REFERENCE:	Nova Bus Manuals
SECTION:	16: Electrical system
RS N°:	MQR 7621-1331
EFFECTIVE IN PROD.:	LB45 (2018AL)

SUBJECT:	Throttle pedal sensors (TPS) cable replacement for 60-ft buses			
JUSTIFICATION:	Cummins code 1242 for throttle pedal sensor circuit			
LEVEL	DESCRIPTION	DIRECT CHARGES		TIME
		LABOUR	MATERIAL	
1	Install the throttle pedal sensor bypass cable.	Client	Client	2.75 h
2	Install the throttle pedal sensor front to back cable.	Client	Client	16 h

**DCP-504300**

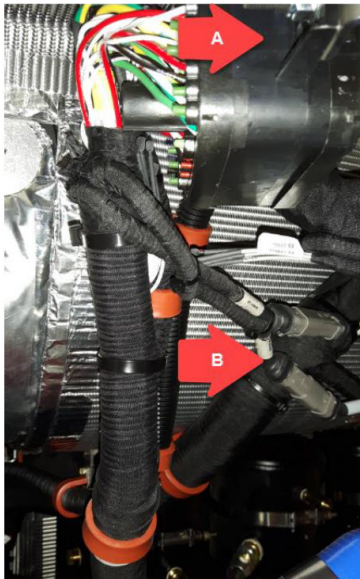
**FUEL PEDAL – EMI interference close to Alternator**

Instructions Spéciales/ Special Instruction		
#	Action	Commentaires / Comments
	Déplacer	<p>Les x2 connecteurs (MT-X9564E) sont situés trop près de l'alternateur, ce qui altère le signal d'accélération de la pédale à carburant (EMI). Déplacer les connecteurs de la localisation A à la localisation B.</p> <p>The 2 connectors (MT-X9564E) are located too close to the alternator and create EMI to the fuel pedal signal. Need to move connector from location A to location B (see picture)</p>

- If DCP-504300 was not properly implemented, relocate the two TPS cable connectors further away from the alternator by following the instructions provided.
